Technical Service Information

THM 440-T4 NEW 1-2 BAND ASSEMBLY

Figure 1

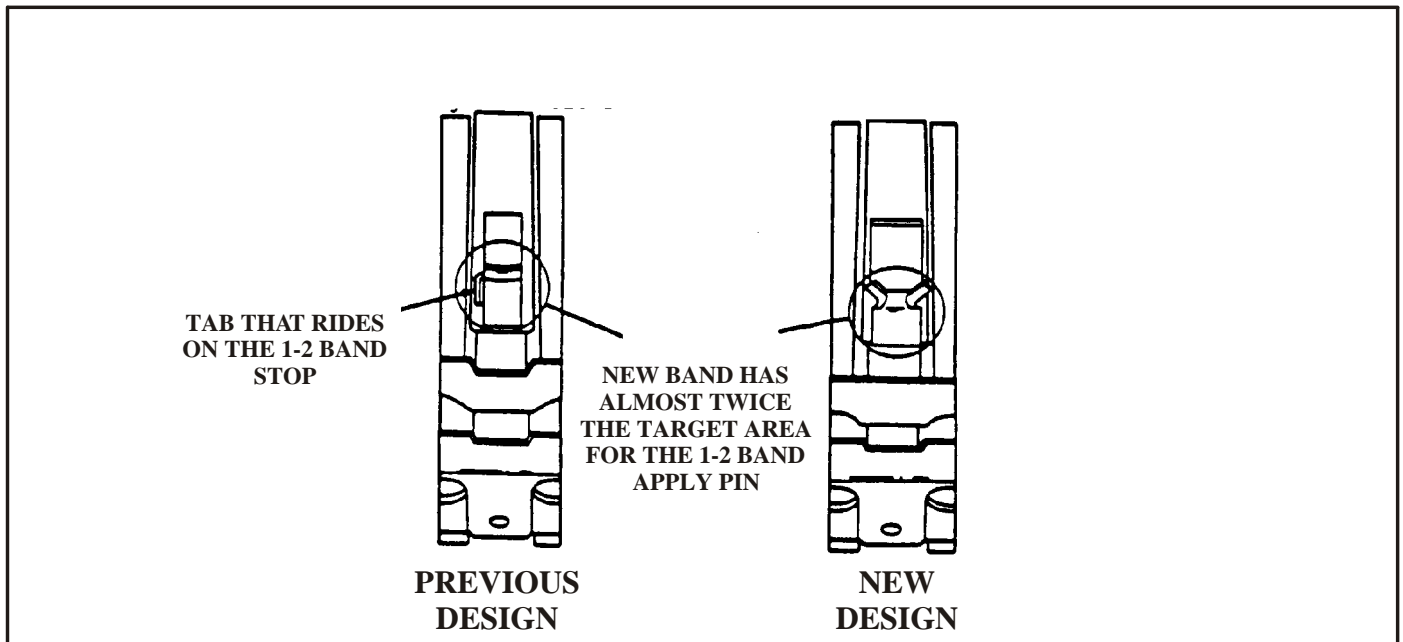
PARTS AFFECTED: (1) 1-2 BAND ASSEMBLY - The target area on the new 1-2 band, where the band apply pin engages, has been made wider and has "Win8s" added to prevent the pin from ever missing the "Target" area (See Figure 1).
(2) 1-2 BAND STOP ASSEMBLY - The 1-2 Band Stop has been eliminated as it is no longer needed (See Figure 2).

Figure 2

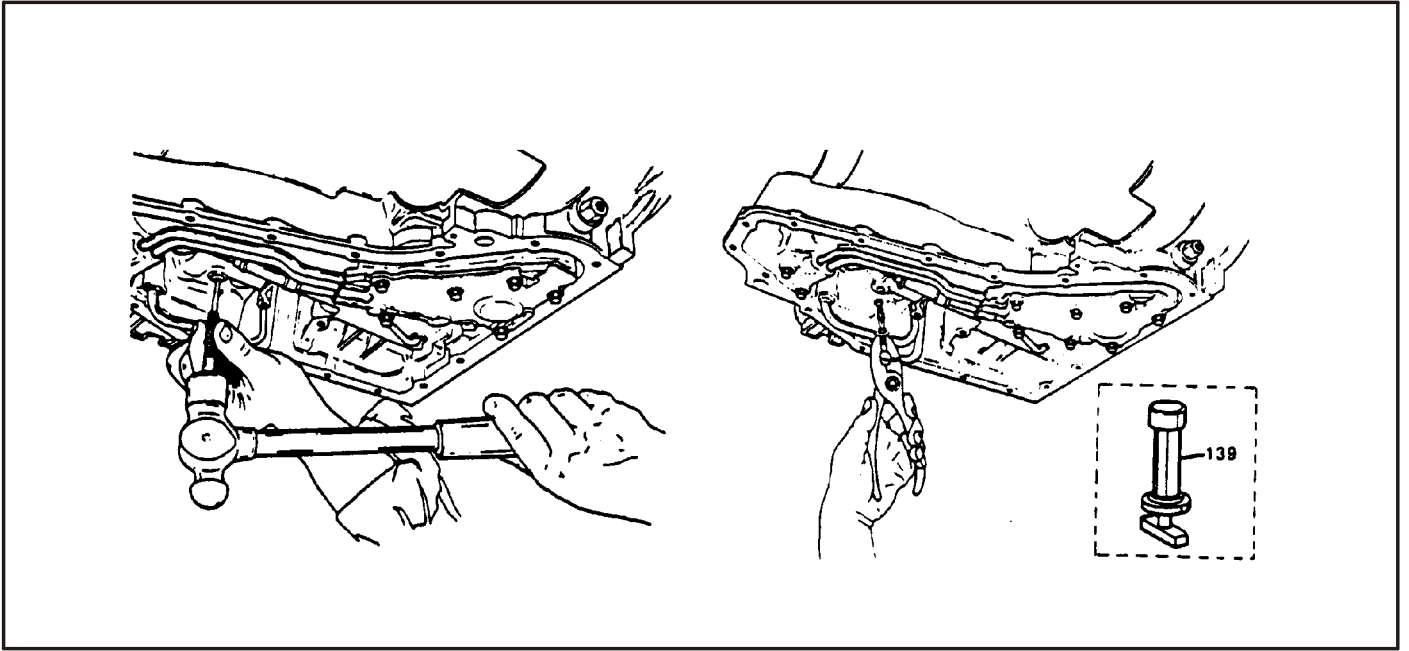
The new style 1-2 Band Assembly can be used to service ALL past models, but the 1-2 Band Stop **MUST** be removed and discarded (See Figure 2). If the new 1-2 Band Assembly is used in a case with a 1-2 Band Stop, interference may result and band durability may be affected.
